**THE
NATIONAL
BOARD**
OF BOILER AND
PRESSURE VESSEL
INSPECTORS

SUBGROUP ON PRESSURE VESSELS AND PIPING

Minutes

*Meeting of July 17, 2012
Columbus, Ohio*

Figure 1

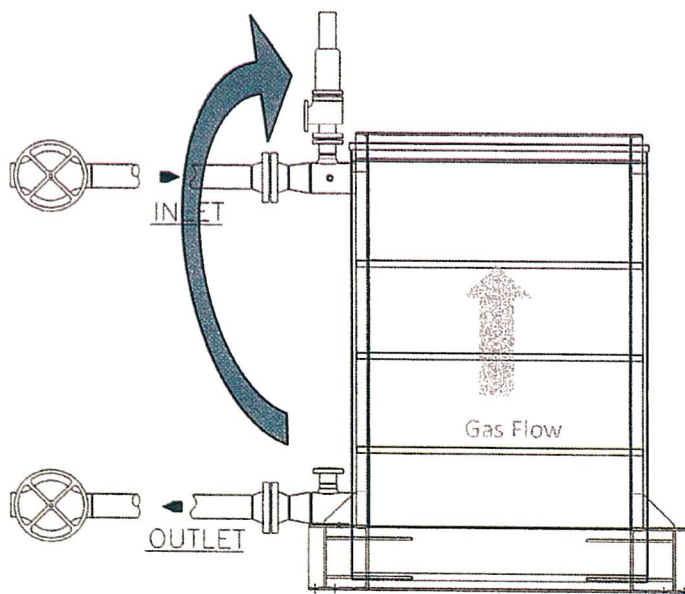
Paul Edwards		I would like to see a response to Mr. Pillow's concern.	03/26/2012
James Pillow		Jpillow 3/21/12 I disapprove because the proposal is an attempt to re-write ASME Section I rules that already address mounting of pressure relief valves. Section I does not allow the mounting of the valves "as recommended by the Manufacturer". Keep in mind that Part 1 of the NBIC does not overrule the Section I rules.	03/21/2012
Donald Patten		Mr. Richardson, I queried Mr. Olson at Victory Energy and below is his comments: Locating the PSV at the outlet without specifying an outlet location does not support an idea that the outlet of an isolated economizer is the strategic location for the PSV. The commenter is correct that, when the economizer is isolated, rarified fluid will immediately begin to collect at the upper areas. Due to the fact that the PSV can be set very close to operating pressures, the time element may not always come into affect. Anyway we look at it, allowing or the PSV location to be determined by the Designer is most beneficial. Regards, David Olson	03/21/2012

John Richardson		I approve this ballot with some hesitation. During normal operation the cooler, more dense fluid if water or wet steam would be entering the top of the exchanger. The valve is apparently sized for steam but is the slower discharge rate advisable ?? When isolation occurs a sudden transient would follow in which the more rarified fluid would collect at the top. Is it possible that the original requirement to place the PRV at or near the outlet was due to the time element?? How rapid is the pressure rise in the heat	03/07/2012

This is more of an editorial comment, but I believe it would be better stated below; The safety valve shall be installed in a location either recommended by the manufacturer, or if no recommendation is provided shall be located as close as practical to the economizer outlet.

Robert Wielgoszinski		I vote negative on this in support of the other negative ballots. First, was this item discussed at the Part 1 Installation subcommittee meeting? If so, what was the result of the deliberation? Was there a vote taken? What was the result of that vote? Secondly, this proposal conflicts with the intent of the ASME Code Section I and inclusion in the NBIC would usurp the completion of ASME Code requirements. If this valve alignment is something that is allowed or common in other international boiler standards, then perhaps the	04/11/2012

Michael Webb	To Jim Pillow's comment: Seemingly the original code of construction may be circumvented. As indicated by the statement of need, there is no intent to deviate from the requirements of ASME Section 1 or Section VIII, Div.I as applicable; but the proposed language as stated does not align the manufacturer to the original code of construction. In my opinion, Mr. Pillow's comment needs to be addressed and the language refined to reflect an alignment to the original code of construction. M. Webb	04/11/2012
George Galanes, PE	GWG 4/11/12; I am changing my vote from approve to disapprove. After further re-consideration and no follow-up response to Mr. Pillow's original comment regarding Section I rules by the PM, I believe the proposed change is unnecessary because the NBIC is not a construction code. There is no need to reference the Manufacturer's recommendation in locating a PRD. The original wording is acceptable and does not conflict with Section I.	04/11/2012

Bob Reetz	I would like to change my vote from approve to disapprove after viewing Mr. James Pillow's comments. We should not be addressing this issue as it is the jurisdiction of Section I and should be handled there. Part I of the NBIC cannot be used to overrule Section I. The request should be handled by Section I. Section I, Figure PG 58.3.1(b), shows the location of a safety valve for an isolable economizer to be the outlet and not the inlet. I am not sure if Donald Patten has viewed this section.	04/02/2012
Donald Patten	<u>NB11-2001</u> I looked at ASME 2007 edition Addenda 2009 and found nothing stipulating the location of a relief valve for isolable economizers. Please see a copy of the attached from said edition. If anyone can point me in the direction of where I can find this information I would greatly appreciate it.	03/27/2012
Donald Patten	<u>NB11-2001</u> I responded with a copy of the attached from ASME. I could not find any stipulation for isolable economizers relief valve location. I had asked Mr. Pillows to please provide this information so I could review.	03/27/2012

An economizer that may not be isolated from a boiler does not require a safety relief valve. Economizers that may be isolated from a boiler or other heat transfer device, allowing the economizer to become a fired pressure vessel, shall have a minimum of one safety relief valve. Discharge capacity, rated in lbs/hr (kg/hr), of the safety relief valve or valves shall be calculated from the maximum expected heat absorption rate in Btu/hr (Joules/hr) of the economizer, and will be determined from manufacturer data, divided by 1000. The safety relief valve shall be installed in a location recommended by the manufacturer. when no recommendation exists the location shall be as close as practical possible to the economizer outlet.

Figure 4.6.xxx Carbon Dioxide Phase Diagram

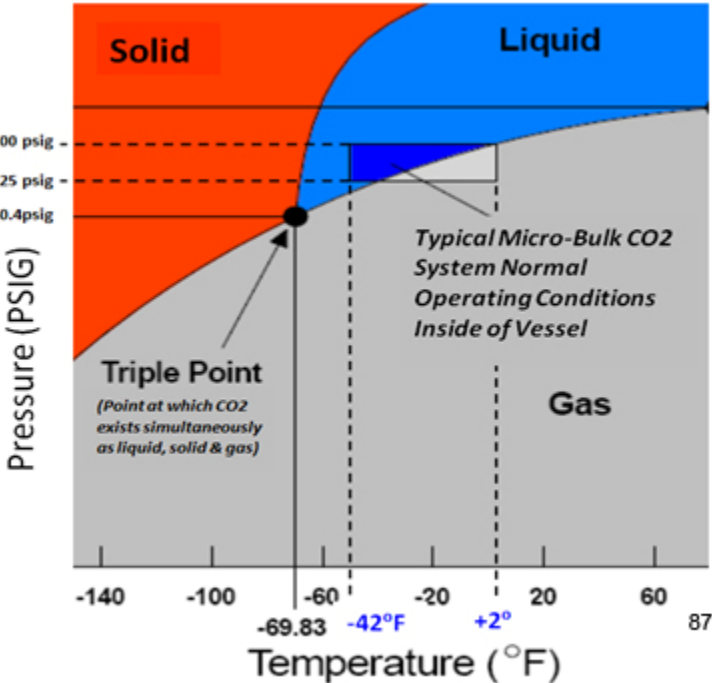
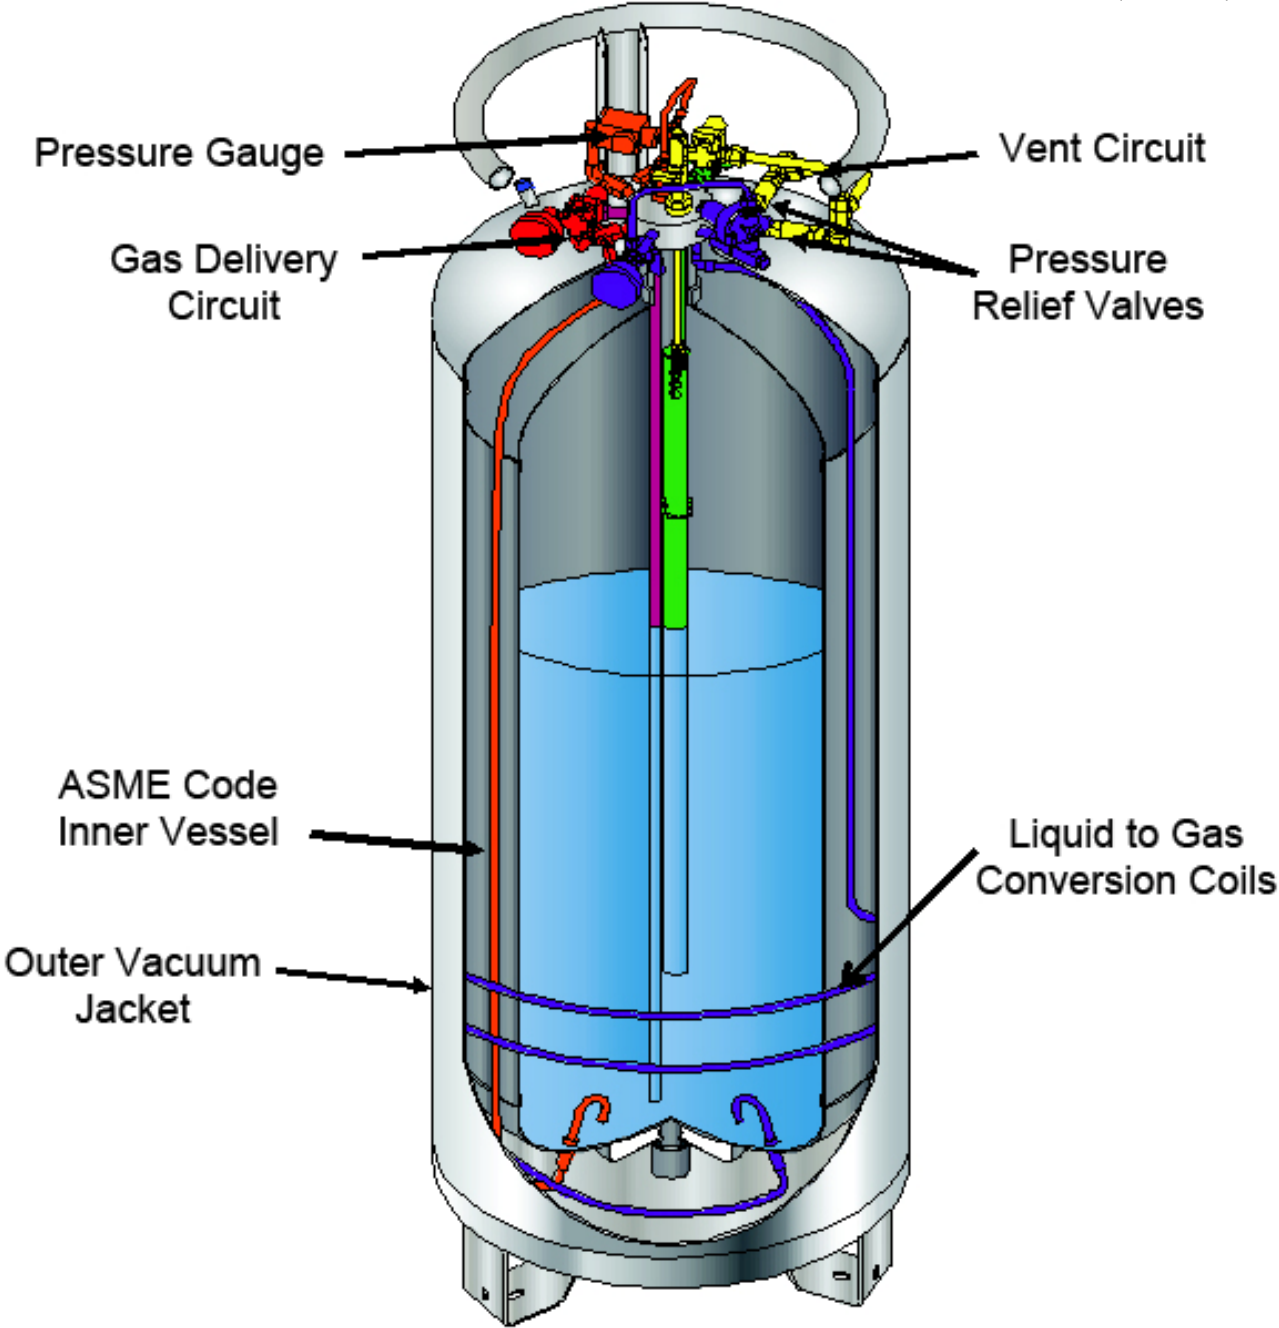
1. The phase diagram included as part of the proposal is not consistent with publically available data. For example, the published triple point is -56.6°C (-69.88°F) at 5.11 atmospheres (60.417 psig) (1 atm = 14.7 psia). Four significant figures of precision requires the change.

2. The figure shows an intersection at 125 psig and -42°F with no corresponding explanation in the text.

Alternative: If the figure is changed to -70.0°F (three significant figures consistent with 60.4), I would withdrawn my negative.

Suggested solution: delete the axis labels and intersection lines or provide and explanation in the text.
